49-0946

NECESSARY FLYWHEEL CLEARANCE TO REPLACEMENT LEFT CASE ONLY

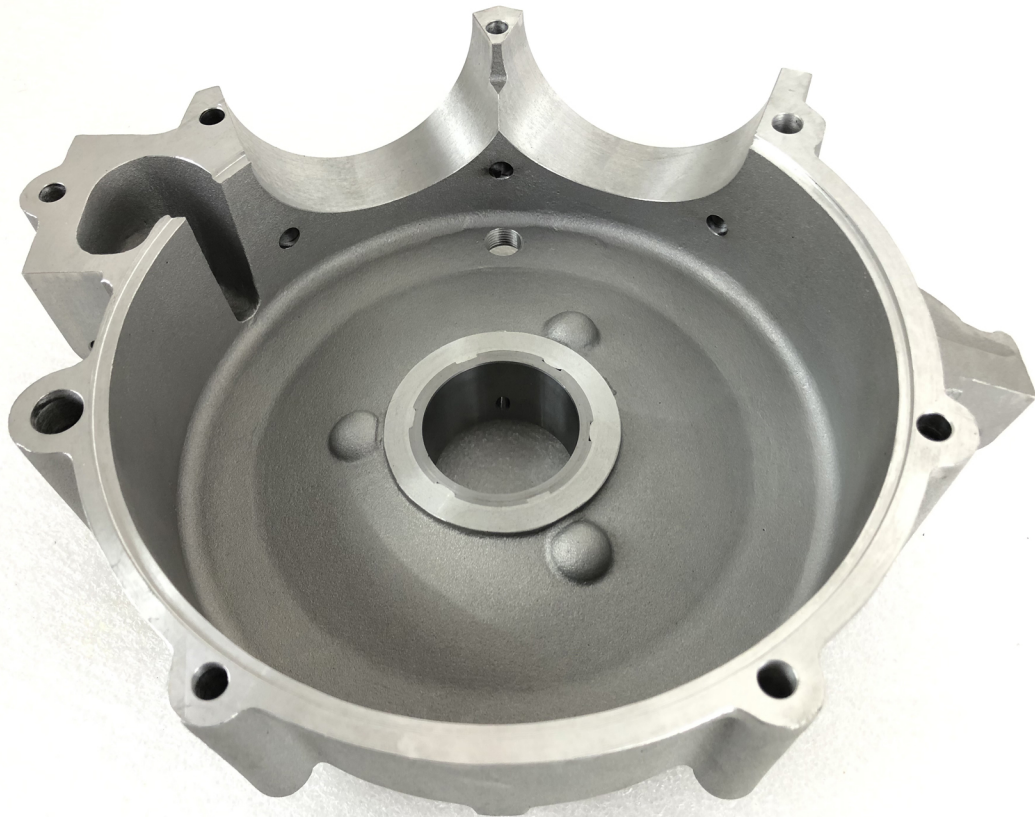
THE DEPTH OF THE FLYWHEEL SIDE MAY NEED TO BE INCREASED. MEASUREMENT FROM CENTER CRANKCASE JOINT SEEM DOWNWARD SHOULD REACH A DEPTH OF 2.400. AREA NEAREST THE OIL SCRAPER NEEDS THE MOST MATERIAL REMOVED.

CYLINDER BASE STUD HOLES ARE TOO SMALL. 3/8-16 THREAD AND NEED TO BE 7/16-14 THREAD.
